MECKLENBURG COUNTY
GROUNDWATER & WASTEWATER SERVICES

Re: Septic system repair options
13756 Thompson Place Dr.
Parcel 195-103-06
GWS File # 4746B

Subject: Site Evaluation of Lot 7 Thompson Place
Location-13756 Thompson Road, Charlotte

Re: Failing Subsurface Wastewater System, Located at 13756 Thompson Place, Mint Hill, NC 28227 (Lot 7)

13756 THOMPSON PLACE DRIVE

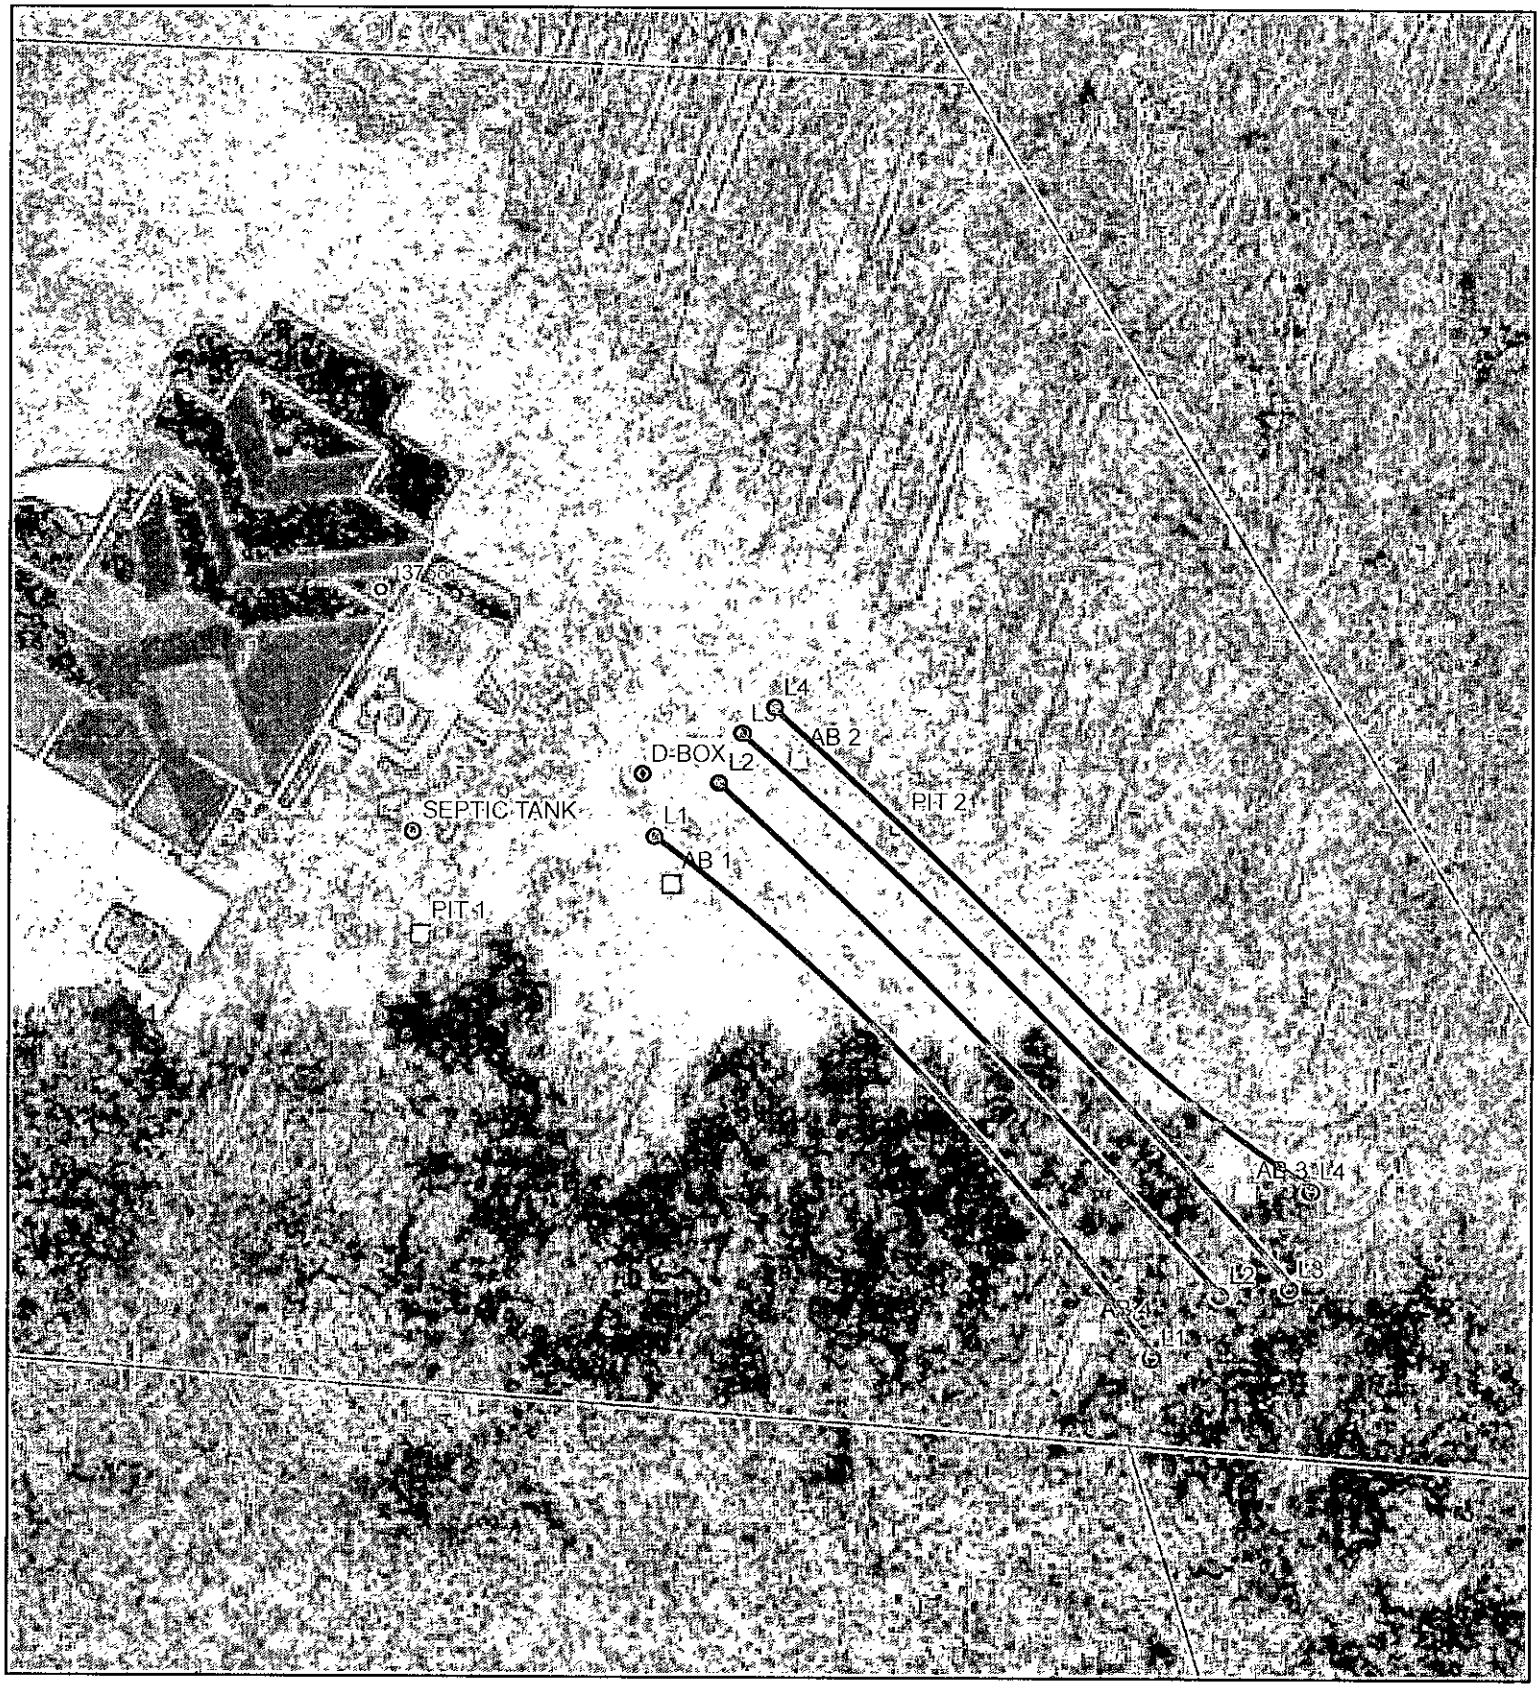
We have completed our review of the site and soil evaluation conducted on April 12, 2010. Based on the information that is available we are presenting you with two options for repairing the septic system at your property.

1. Pump the 1,500 gallon septic tank.
2. Uncover the distribution box and inspect for damage. If damaged, the box must be replaced. If the box is serviceable the speed leveler for the lowest line (#4) shall be adjusted so that the line only receives overflow from the other lines. The speed levelers for the remaining three lines shall be adjusted to balance the flow to the drain field.

3. Bring in clean soil, Group III or IV as defined in 15A NCAC 18A. 1955 (b) Table II, to place over the drain field. The soil shall be spread with a tracked skid-steer during dry conditions to prevent soil compaction in the drain field. The drain field shall be filled and shaped so that it is free of depressions and sheds surface water.

4. The swale along the right property shall be reworked so that it channels storm water to the rear of the lot and discharge to the woods.
5. Seed and straw the areas that are disturbed so that a stable vegetative cover can be established over the entire system area.

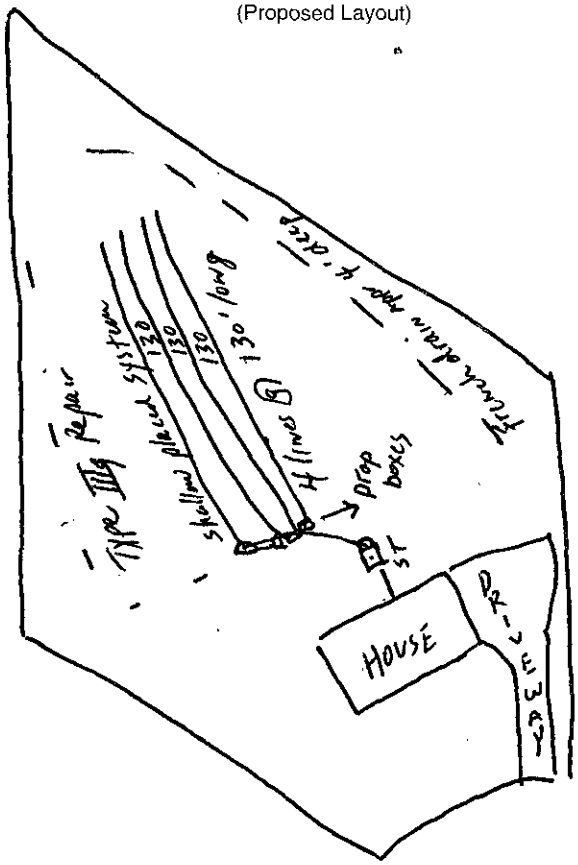
Install french drain >10' above septic system 4' deep / Add 12" soil cover over drainfield
